VARIATION OF CONDITION 2 (APPROVED PLANS)

**ATTACHED TO PLANNING PERMISSION HGY/2019/3050 TO PROVIDE AN AMENDED
FENCING DESIGN WITH INCREASED HEIGHT, AND AN INCREASE IN LEVELS OF THE
DRIVEWAY BY UP TO 700MM**

Detail 1

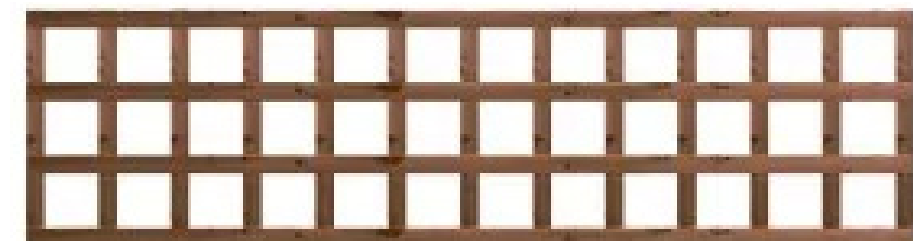
- A 300mm trellis will be attached along the entire East boundary of the 1 Pound Lane property on top of the existing fence. Please refer to Detail 1.

- A 300mm trellis will be added to their East boundary, to the new fence which has been erected along their East boundary. Please refer to Detail 1.

1 POUND LANE	REV 04
FENCE DETAIL AT THE BOUNDARY WITH NR: 11, 9 AND 7	
SK.NR: C7M-85447-SK-041

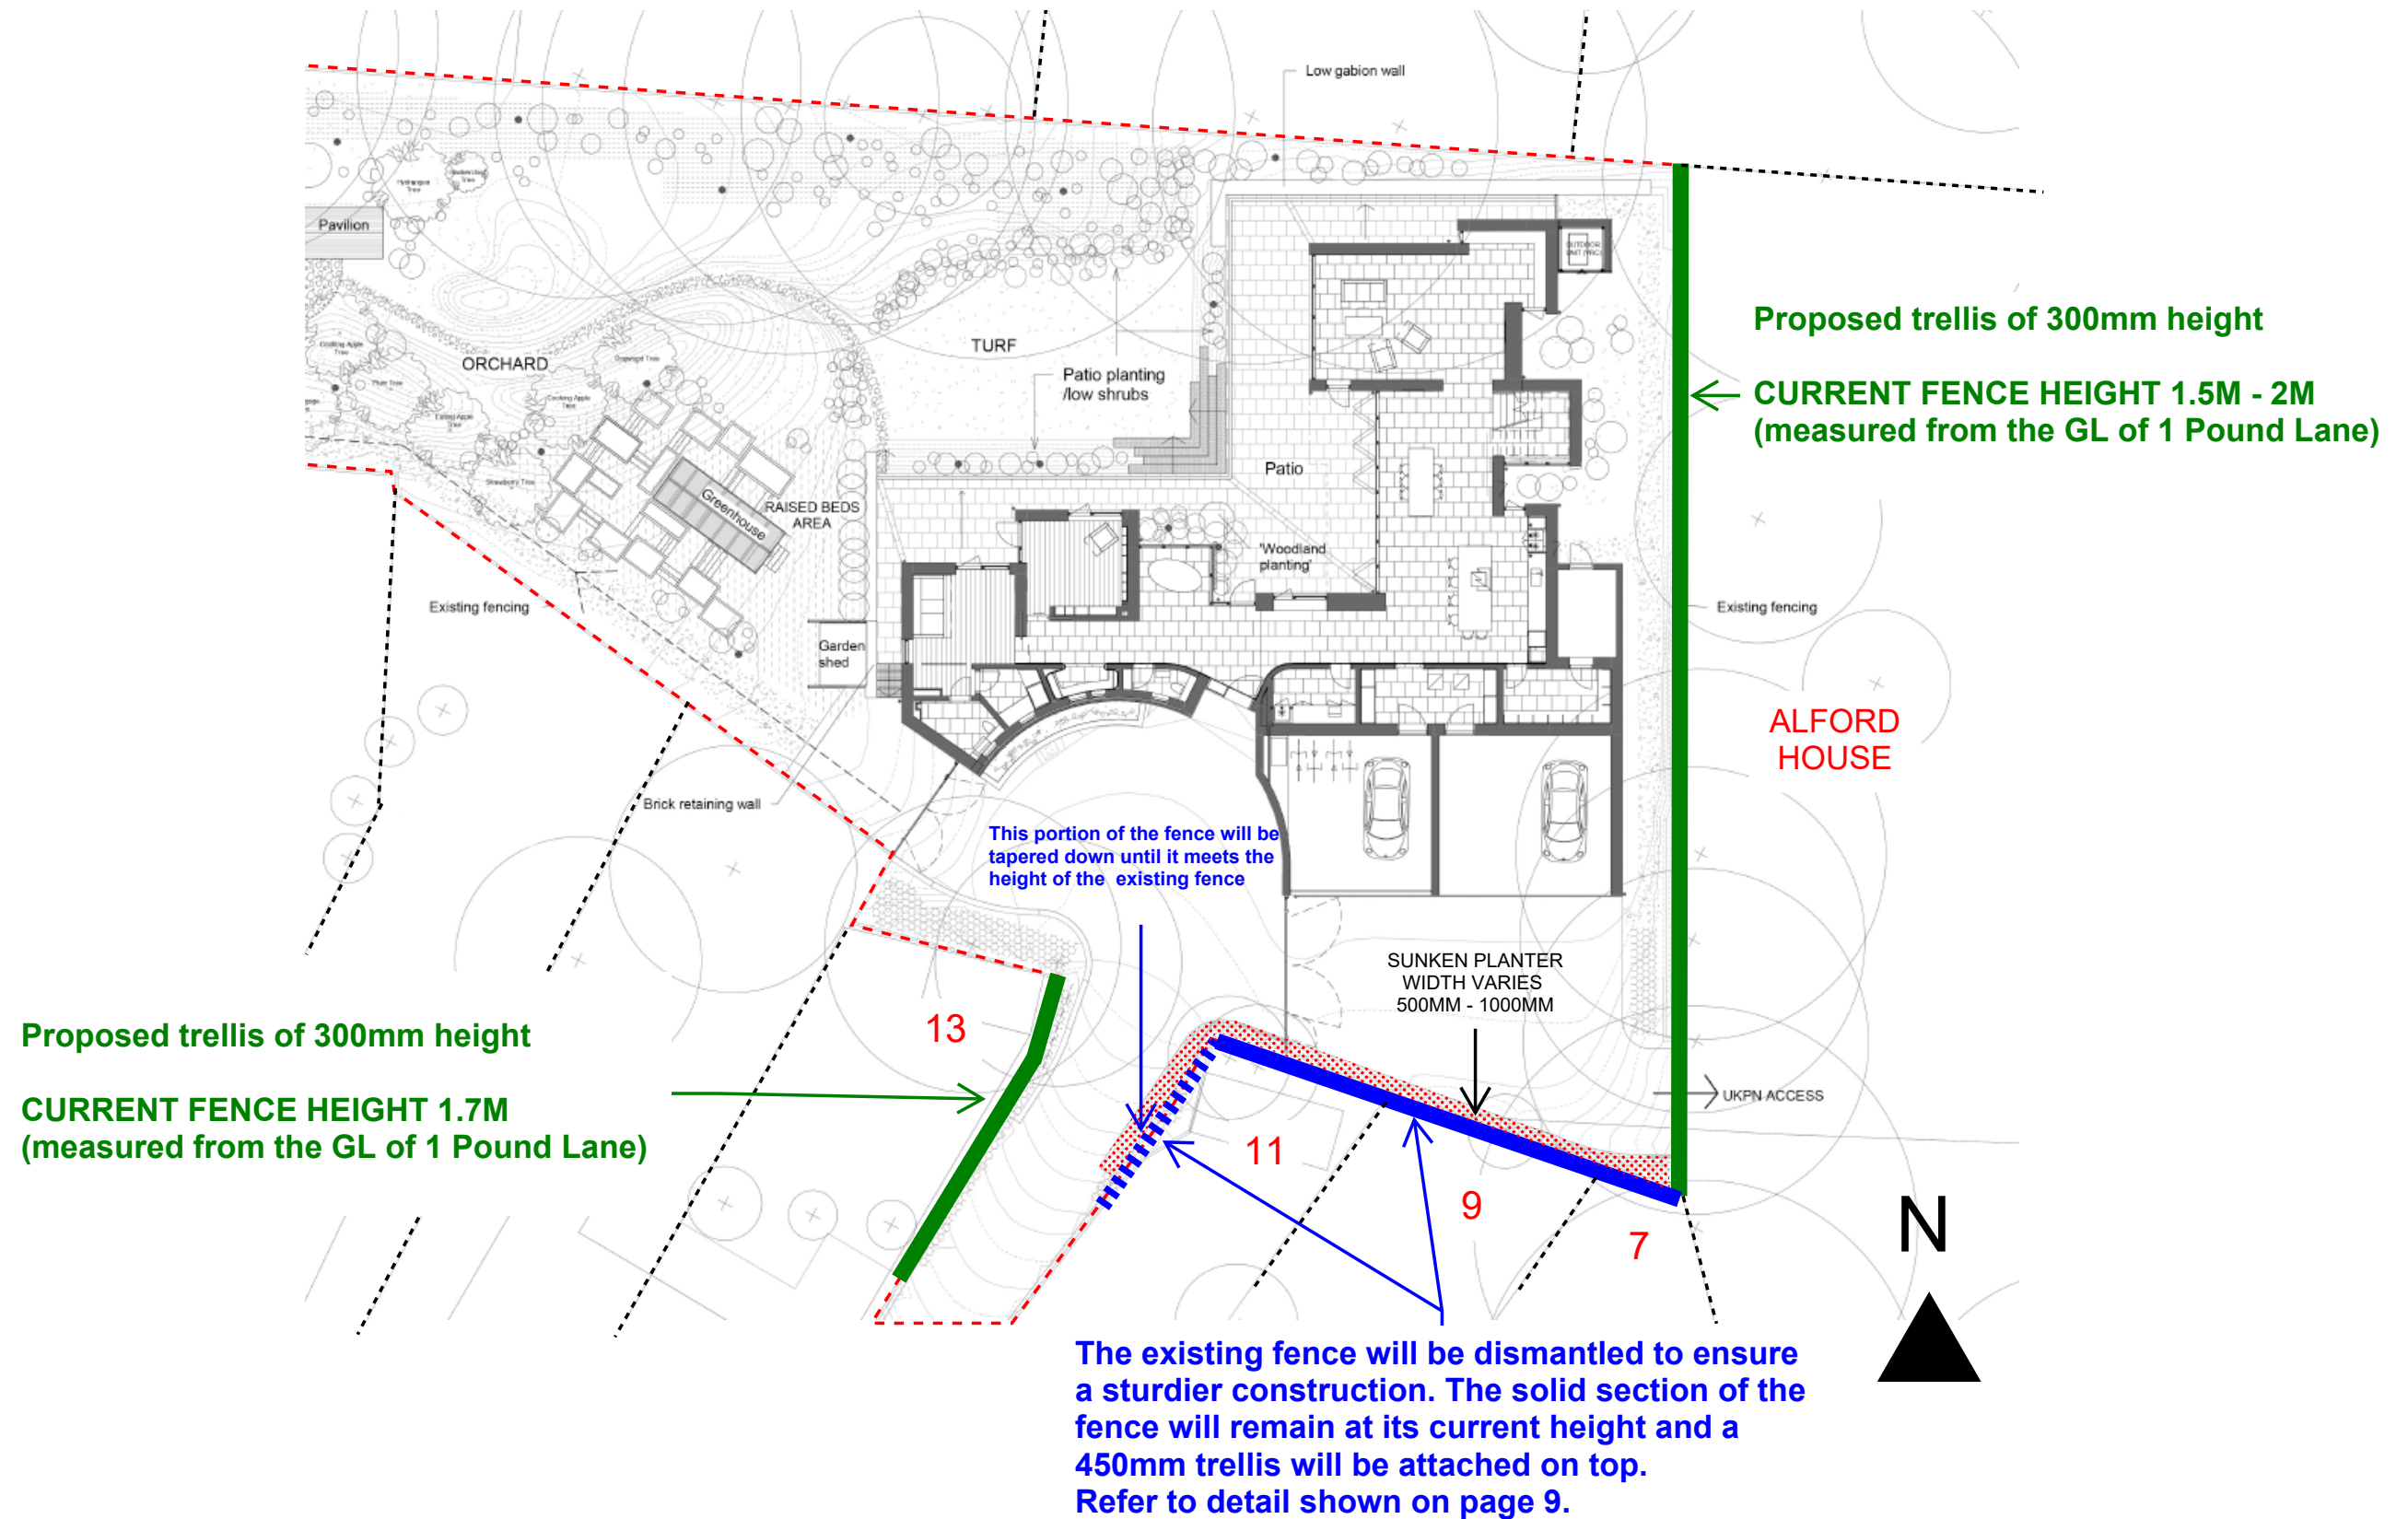
- The newly constructed fence will be dismantled and replaced with a fence featuring concrete posts securely anchored in the ground, accompanied by a 600mm gravel board at the base to support the topsoil. A 450mm trellis will be installed on top.

- The solid section of the fence will remain at its current height, while a 450mm open trellis will be added, resulting in parts of the neighbouring gardens having a fence exceeding two meters in height.

- To be noted that the application drawing indicates a gravel board height of 600mm. This measurement only serves as an indication of the height of the concrete gravel board and should not be interpreted as the proposed increase in ground levels. The updated sketch demonstrates how the levels against neighbouring properties will be adjusted. Please refer to details on page 9 (Ref: CFM-85447-SK-041).

PROPOSED EAST-WEST ELEVATION FROM HGY/2019/3050 PLANNING APPLICATION (Ref: 85447-CFM-A-ELE-20-301 Rev 2)

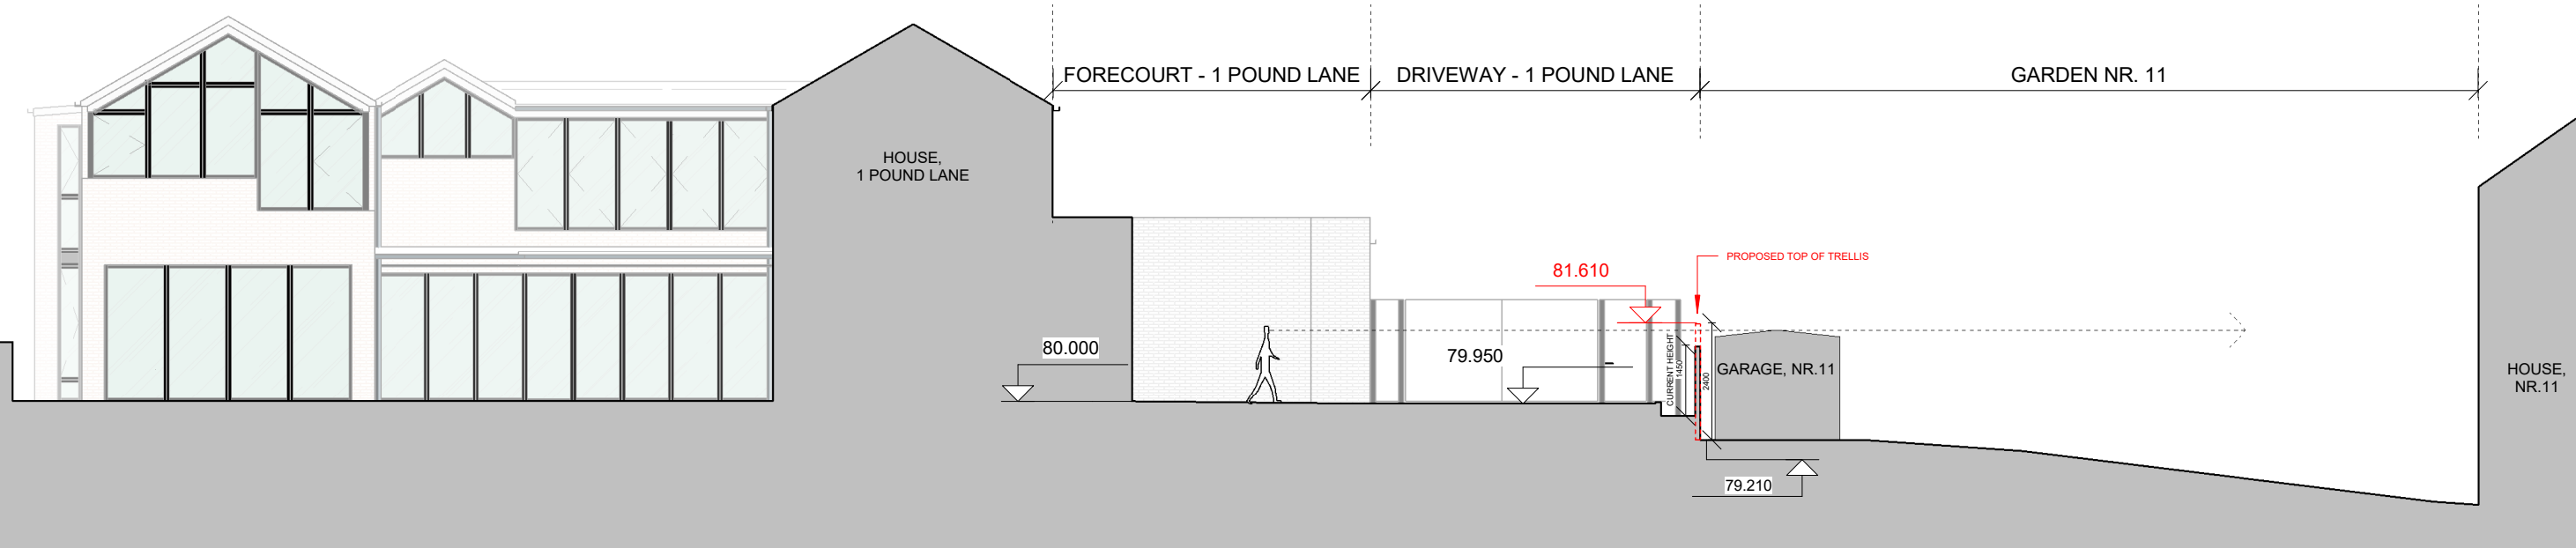
The consequence of the works has been to increase site levels in the South East corner (the driveway and forecourt) by up to 700mm and to amend the boundary fencing height and design in this area.

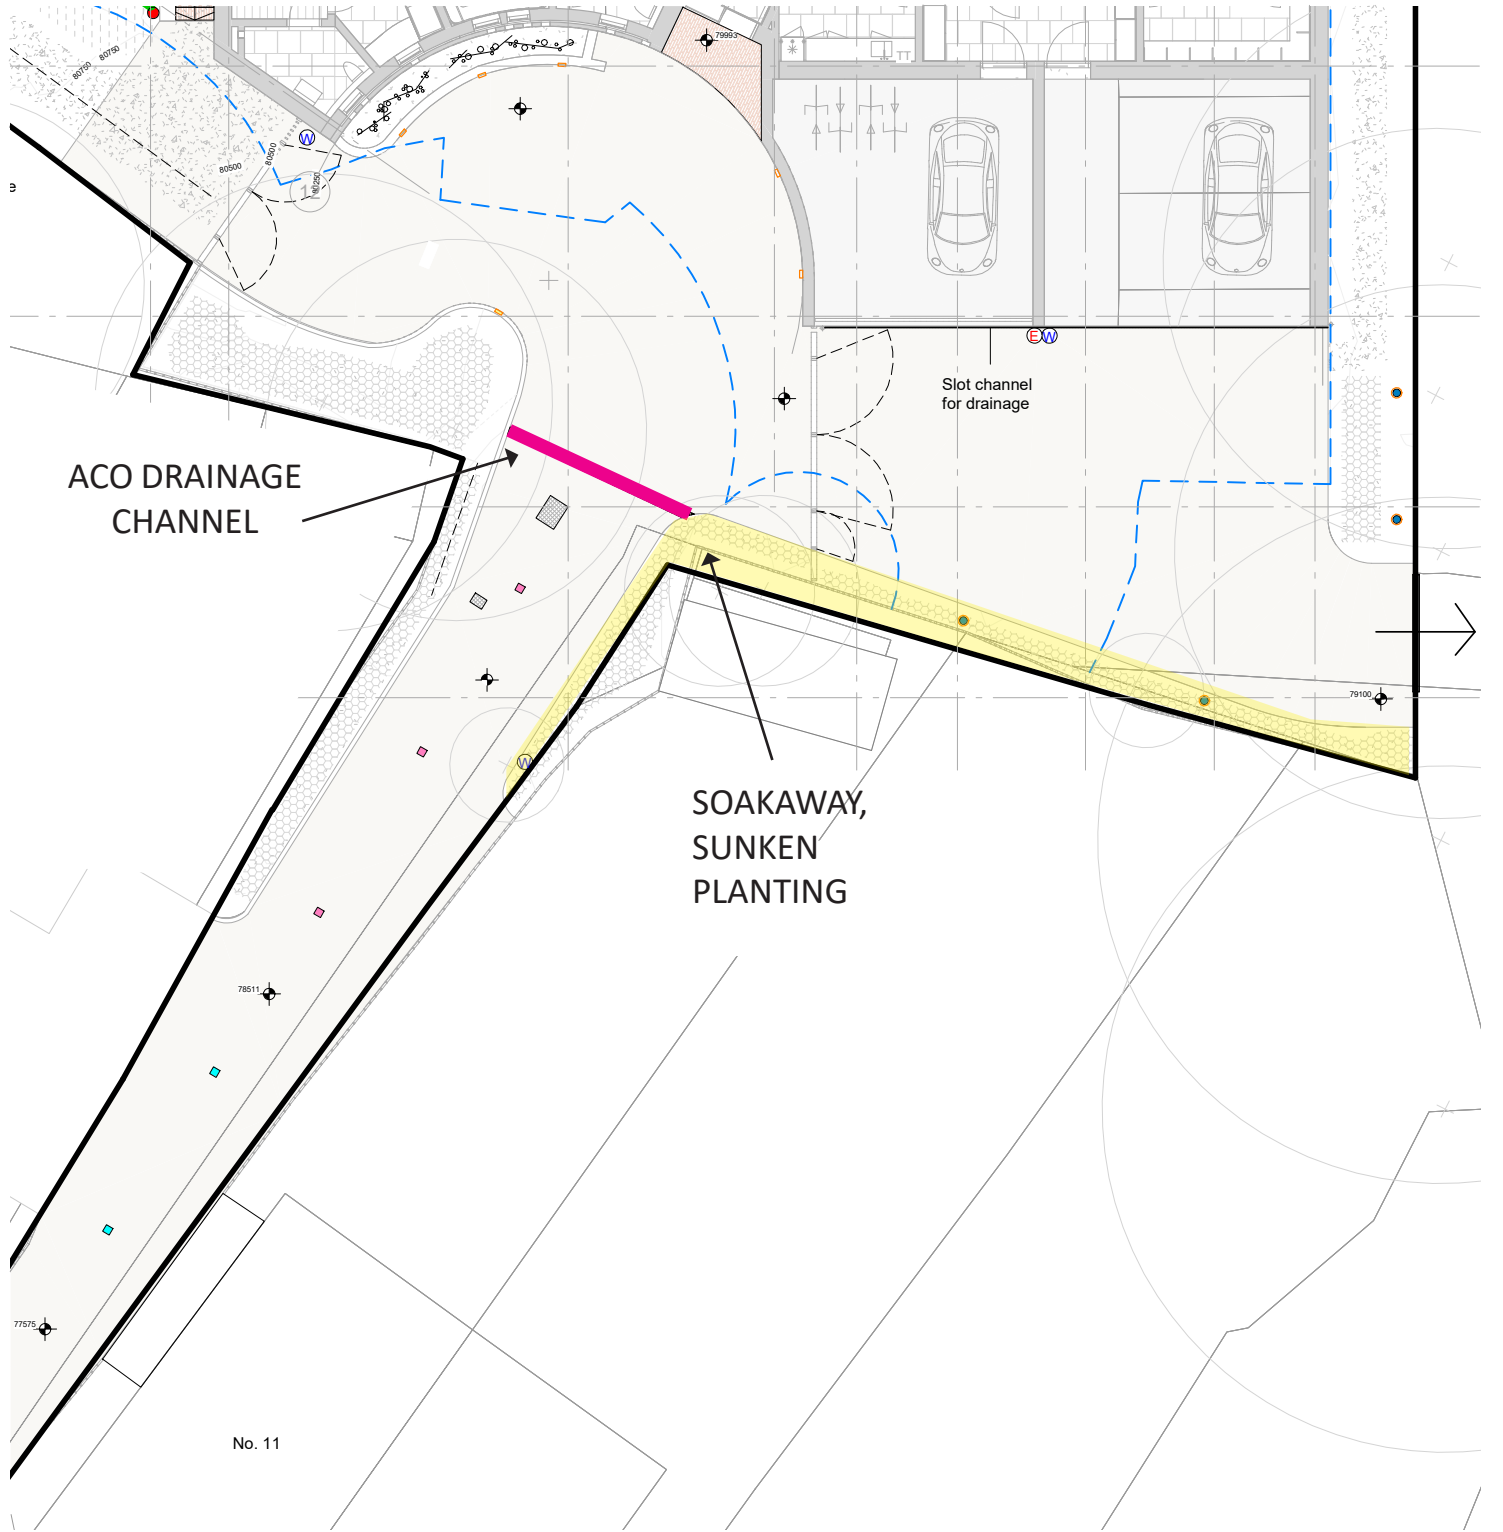
- The new driveway having a curb that catches the water and directs it into a rainwater drainage channel (the ACO Drainage Channel shown on the drawing extract) at the top of the driveway.
- As part of the development, the soil quality has been improved to enhance its permeability, allowing it to absorb water more effectively.

In addition, as a consequence of works to the new fence (described on page 9) a sunken planting bed between the fence and the garage forecourt will be created to act as a new soakaway for any excess water from the area in front of the garage. The planting bed/soakaway will be approximately 0.5m-1m wide from the existing fence starting at the number 11 Stanhope Gardens end, tapering into the Southeast corner. The planting bed will also contribute towards giving a more natural and green setting for the plot.
